Service Note		
Products	Description:	Service note no.
Harmony Singer 2, Mic Mechanic 2, Duplicator, Critical Mass, Talkbox Synth	Power supply startup failures	SNo-T222

Location of L12

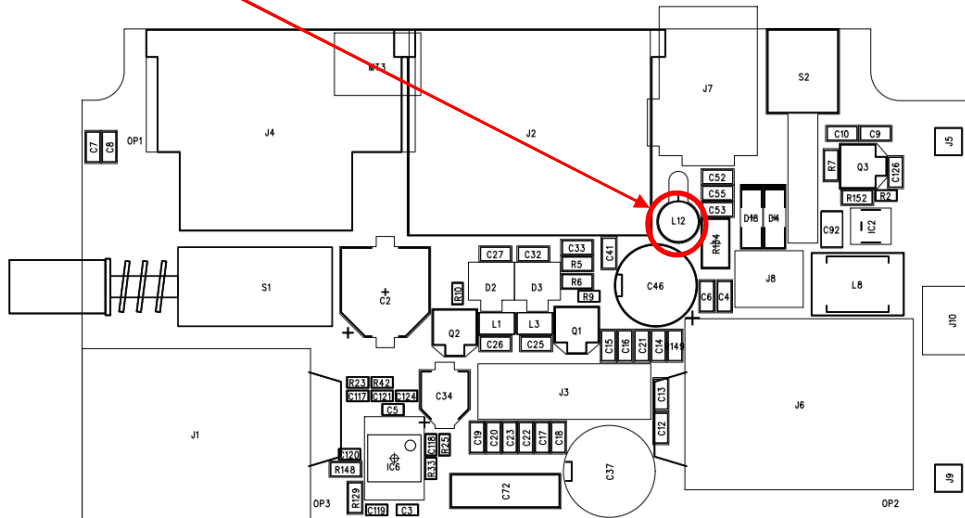
We have seen some of these products being unable to start up with the new TC branded 9V power supplies

To fix this problem the through-hole inductor L12 on the front PCBA, must be replaced with a through-hole resistor (4R7 0.4W 5% metal film) to provide reliable starting.
